PROJECT/LOCATION: 2318 Grand Park Dr.

2100 ft² storage building and an
Construct: 18,600 ft² Office/shop Building for Northwest Machine

File No: SPR 2003-066 Staff Planner: Ronnie Edwards
(To be filled in by City Staff) *(To be filled in by City Staff)*

SUBJECT: Response to Comments – Northwest Machine Shop - (SPR-2003-066).

SHEET NUMBER
DP-1

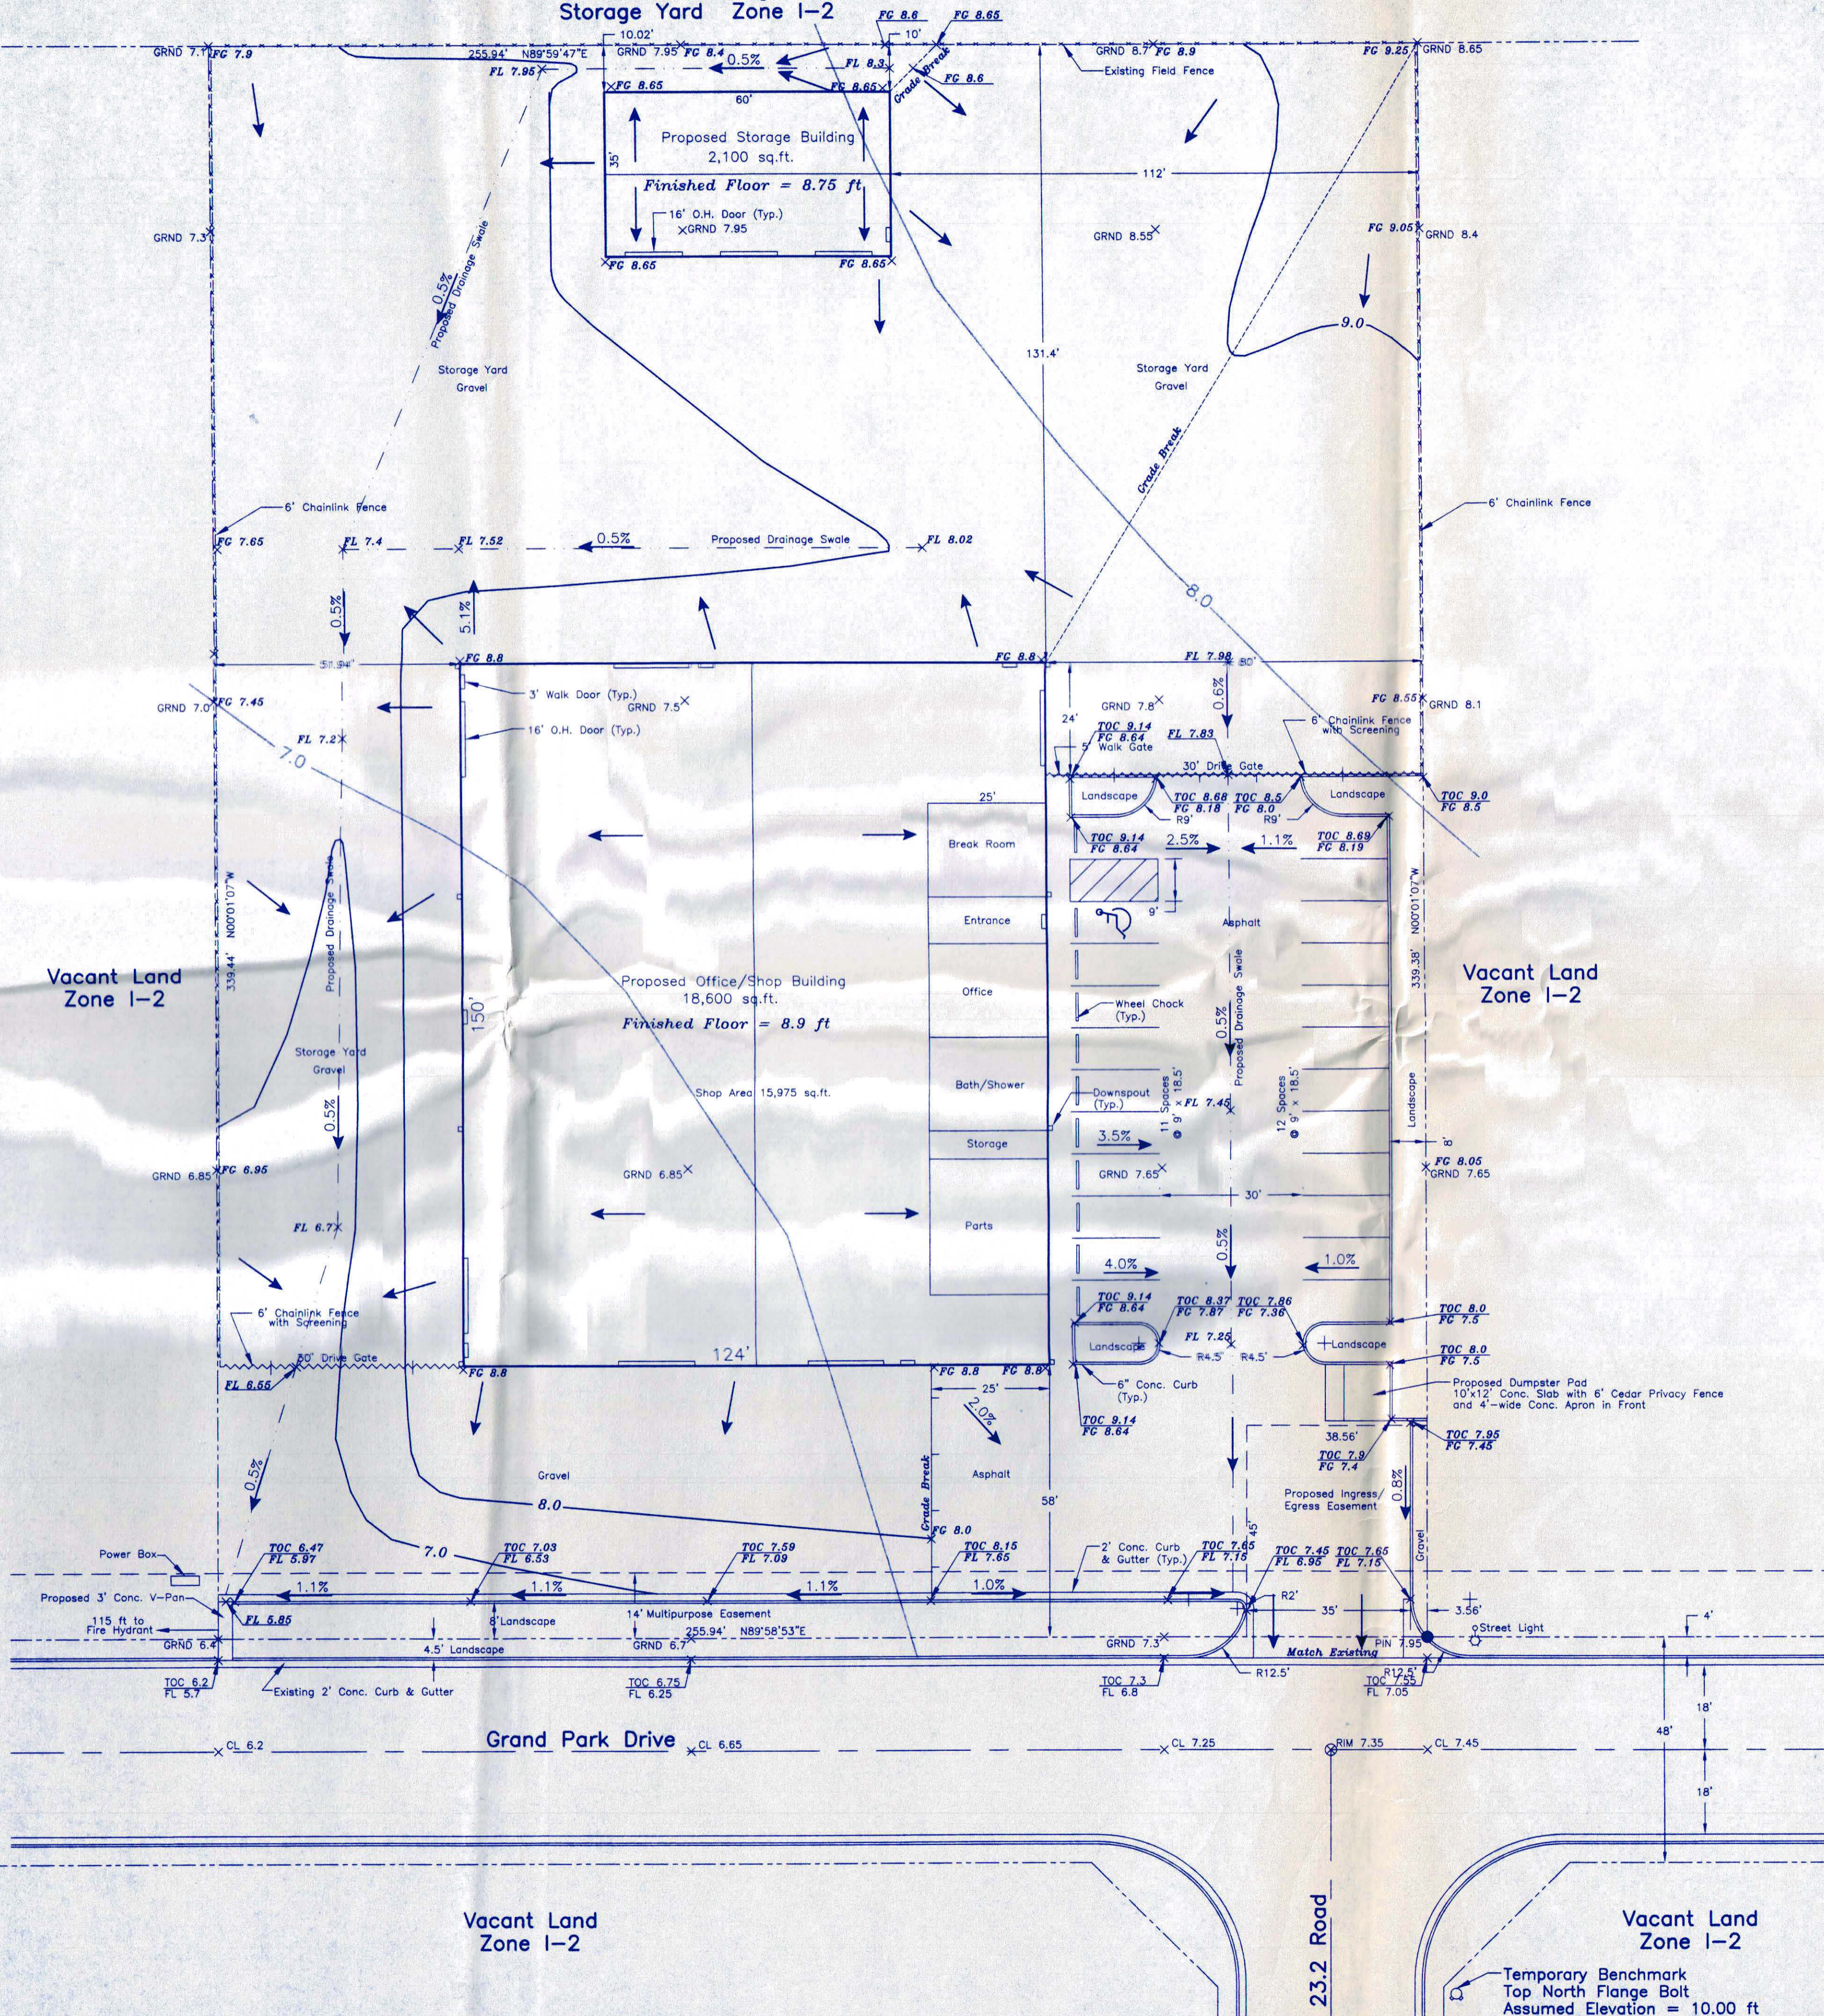
1. Plan submittal is generally complete and addresses all required areas.
2. Proposed drainage swale indicated at centerline of parking area drains at 0.5% longitudinally. Asphalt slopes should be 1% per SWMM and recommended practice. Same general comment with grading of gravel storage yard. Consider V-pan at swale line in parking lot. Grading indicated on plans must be constructed in the field prior to CO
3. TCP : Office : 1760 SF x \$400/1000 sf = \$704
Shop: 15975 SF / 8 employees : 500x 40/10x1x100% =\$2000
Storage: 2100+865 SF x \$244/ksf = \$723
Total: \$3427

- Response 1: Information acknowledged.
- Response 2: A v-pan has been added to facilitate drainage through the parking area.
- Response 3: Please note that the square footage of office and shop, and storage have changed

SHEET NUMBER
SP-1

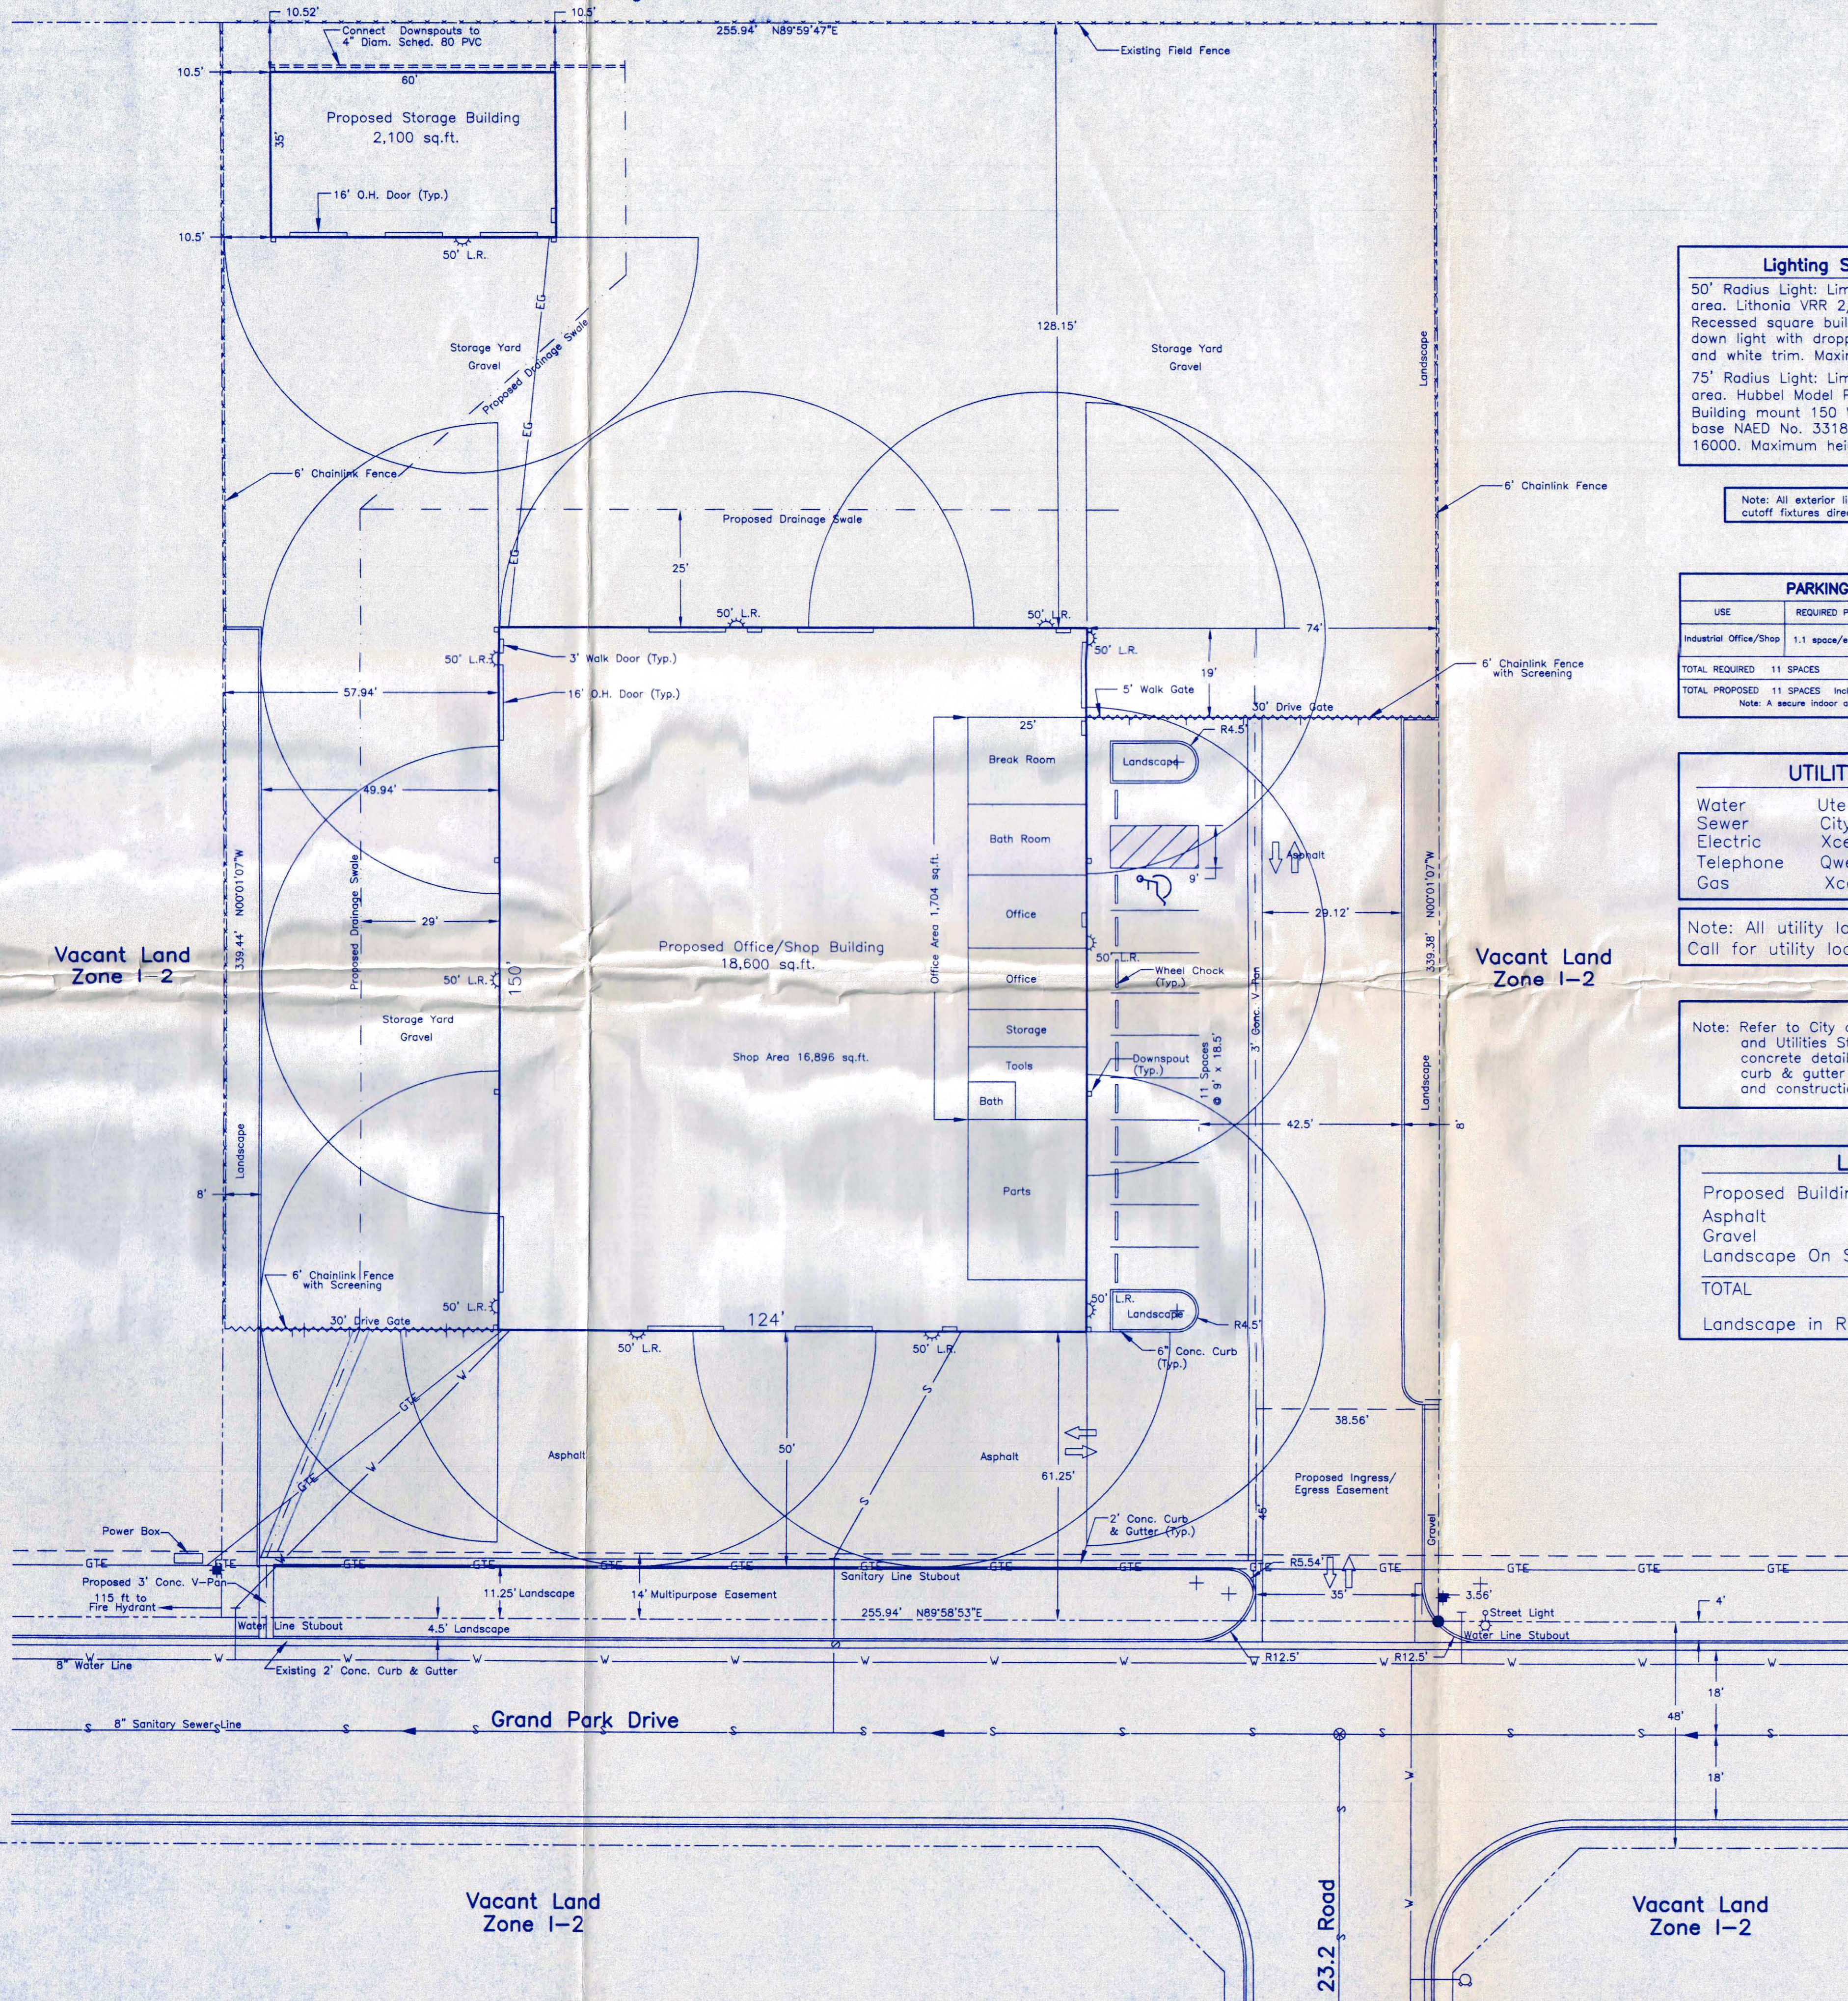
1. There have been recent discrepancies as to the definition of a full cutoff light fixture, which has caused confusion and monetary loss to applicants. Please provide a spec sheet for the lighting proposed for this project.

1. There has been recent discrepancies as to the definition of a full cutoff light fixture, which has caused confusion and monetary loss to applicants. Please provide a spec sheet for the lighting proposed for this project.

1. The front area outside the storage area drive gates cannot be gravel. This area needs to be asphalt. It cannot be counted as storage area as Section 3.4.H states that outdoor storage shall not be allowed in the front yard setback. Provide revised drawings.

- Response 1: There is a note box on the Site and Lighting Plan which details the proposed lighting specifications.
- Response 2: The landscape plan has been revised to meet the current code. The petitioner strongly objects to placing this amount of landscaping on an industrial site. First of all it takes up 11% of the property. Secondly, it will cost thousands of dollars to plant and maintain the landscaping and it will use up large quantities of potable water during a time when W. Colorado is experiencing a prolonged drought (there is no irrigation water for the site). Prior to development, this subdivision was a flat expanse of greasewood brush with no trees (about 28 acres with a density of 1 bush per 500 sq.ft. or about 2500 shrubs). Using the current code standards, this subdivision will have approximately 437 trees and 3,640 shrubs planted as landscaping at full build-out of the 17 lots (25 acres), which far exceeds the prior native vegetation. The point is that the landscaping requirements for this project seem to be very excessive considering the planned use, the site, the cost, and the water requirements. It is our understanding that the City intends to revise the landscape code for industrial uses and it is our hope that there will be a more reasonable requirement made for future developments.

Response 2: The area outside the storage area drive gates will be paved per the revised plans.
